REVISED SUBMISSION

August 14, 2025

Re: 300 Rella Boulevard, Montebello, NY - Site Plan/Special Permit
Acoustical Review of Proposed Warehouse Application Comments

Figure 1 – Measurement Location Map

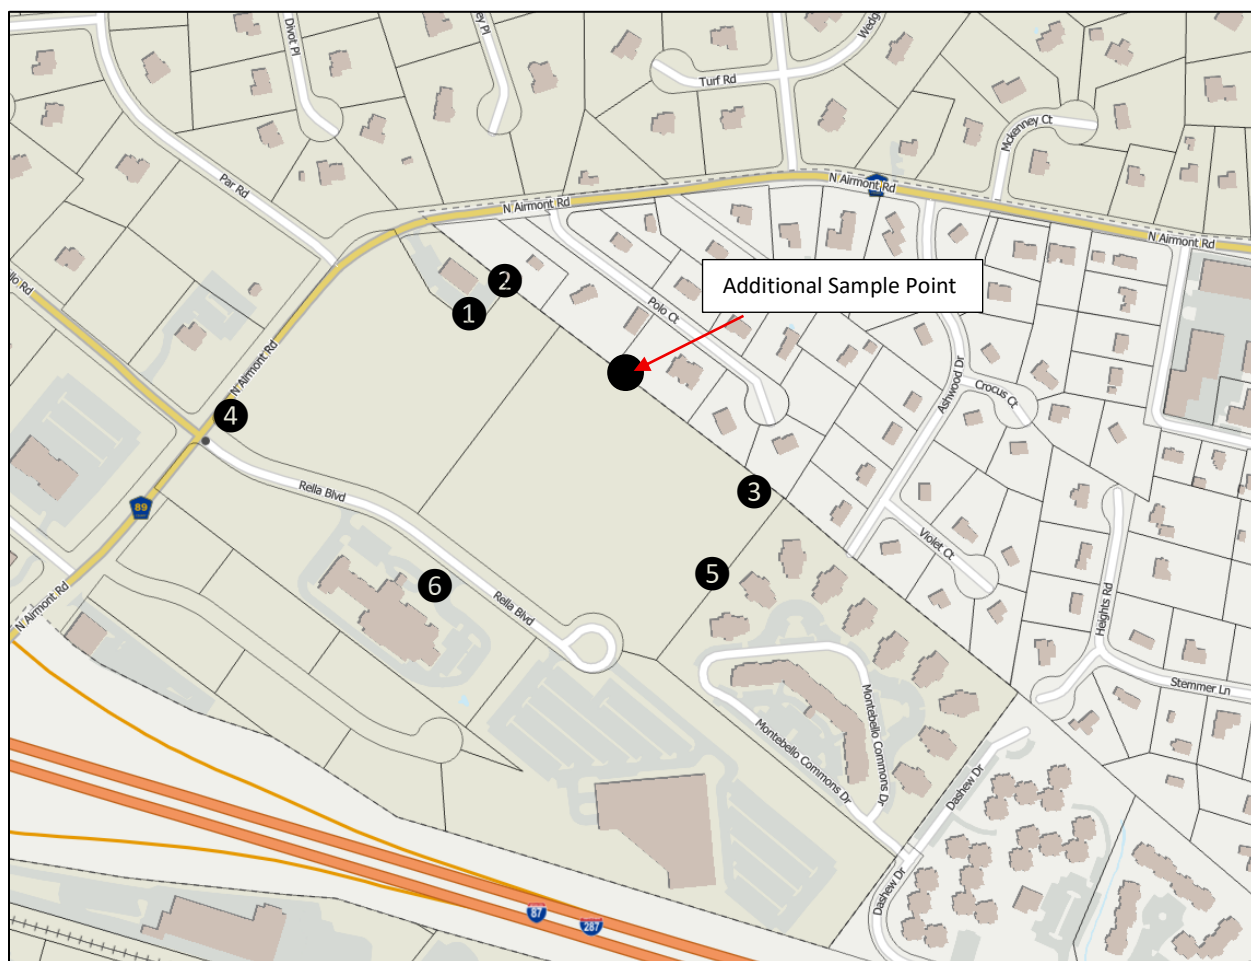
Comment 1: LSG&A is requesting a table summarizing; the baseline measurement locations, land use category, date and time of the measurements, duration of the measurements and the A-weighted (dB(A)) statistical L_{10} , L_{90} and equivalent, L_{eq} , sound level results of the measurements at each Noise Sensitive Receiver.

Please see an updated measurement summary table at the end of this correspondence. Measurements expand several years as B. Laing Associates, Inc. initially conducted noise measurements for the site when it was a proposed lumber yard in 2020/2021.

FIGURE 2
NOISETOOL RESULTS – DAYTIME HOURS

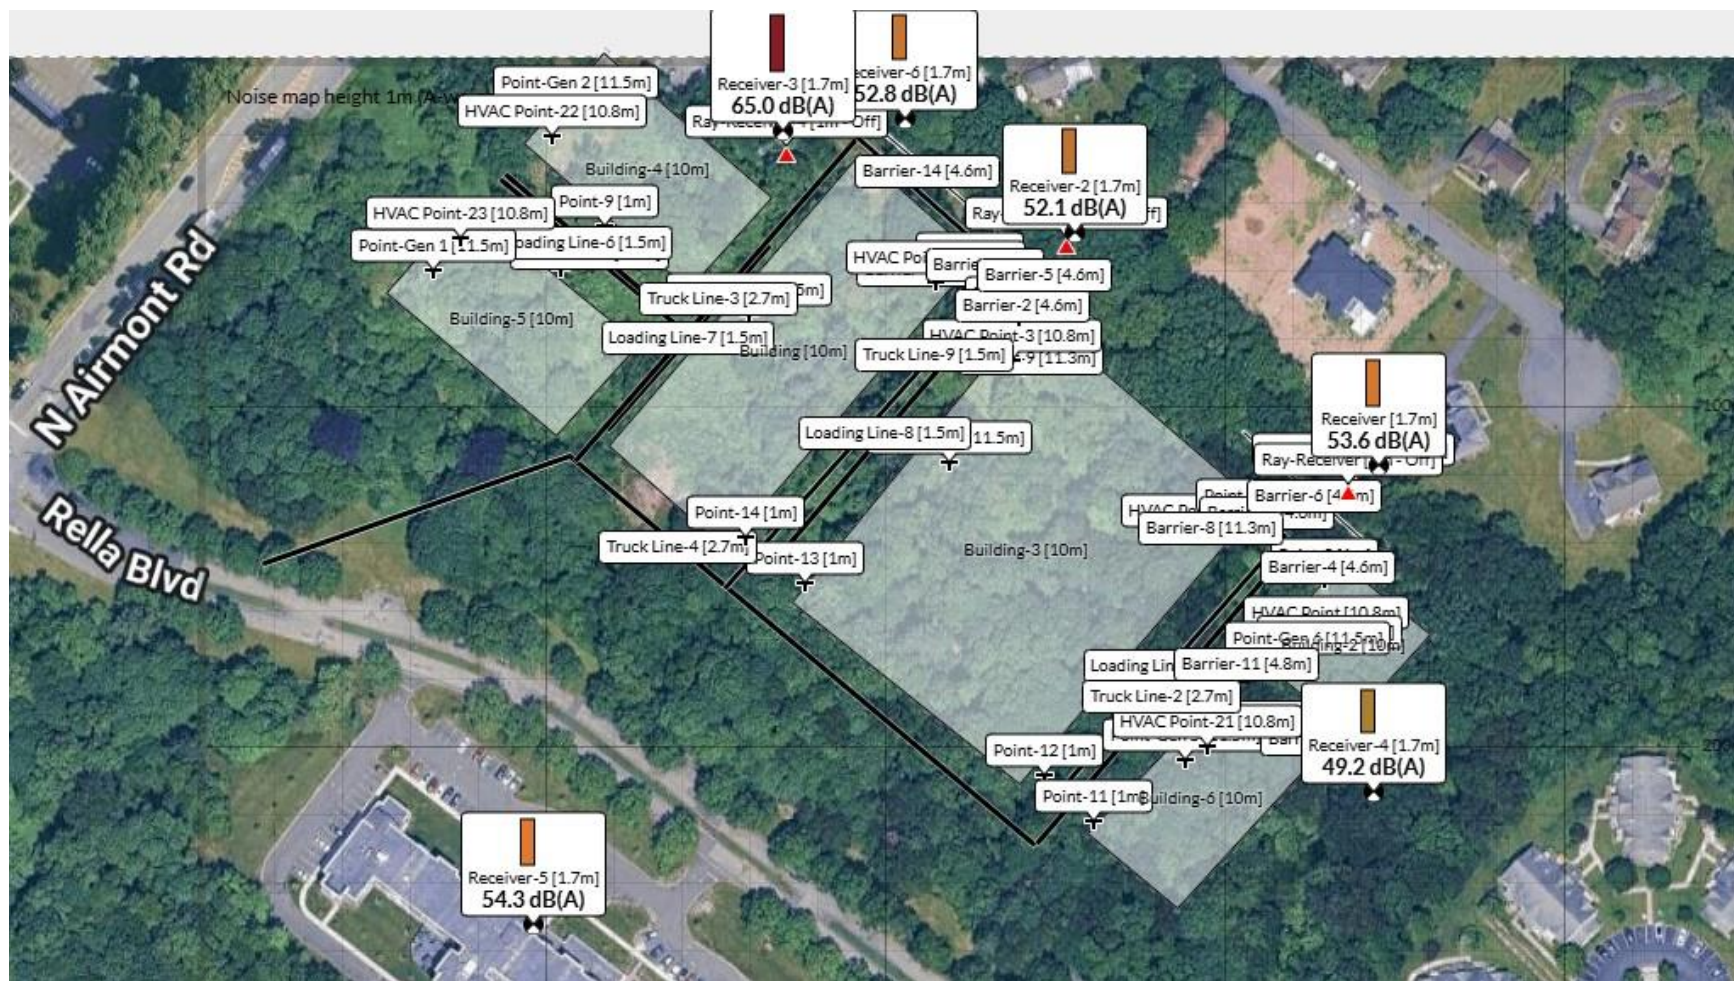
Comment 2: The applicants noise evaluation discusses including several noise barriers included as part of the sound reduction methods in the design, but Figure 3 only shows the location of two "mitigation walls." LSG&A is requesting a figure showing the locations and heights of the proposed barriers. LSG&A also requests more details and information on the noise barrier types and materials.

Two separate 15-foot-high sound walls or sound wall/retaining wall combinations will be installed along the site's northern accessway to provide sound mitigation for Receiver Points 1, 2 and 6 (i.e., residences fronting on Polo Court). Further, two sets of two, 15-foot-high "interior" noise-mitigating walls will be installed as 20 to 22-foot-long extensions of the buildings' northern walls where entrance or emergency access gaps will occur. A third set of 16-foot-high fence/sound barriers will be installed between the eastern buildings, where an emergency access gap is also planned. The buildings' exterior walls and inward-facing noise barrier/wall surfaces will be finished with roughened surfaces to minimize reflections and maximize scattering of sounds from the site's roadways and interior loading bays. Sound absorbing mats will be added to the top of 5 "interior" sound walls on their upper 4 feet (Echo Barriers or equivalent). See Site Plan prepared by Brooker Engineering for further details.
